Product / Process Change Notification (PCN)

PCN #: PCN_ConCOM_20190702
Affected Series: WR-USB2; 61400413321; 614004141221
PCN Date: April 02, 2019
Effective Date: July 02, 2019

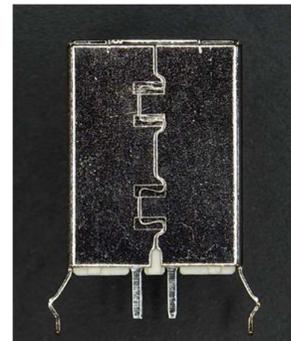
The tools for metal shielding stamping and assembly have been change, in order to improve the shielding fastening.

This change has no impact on the performances of the connector.
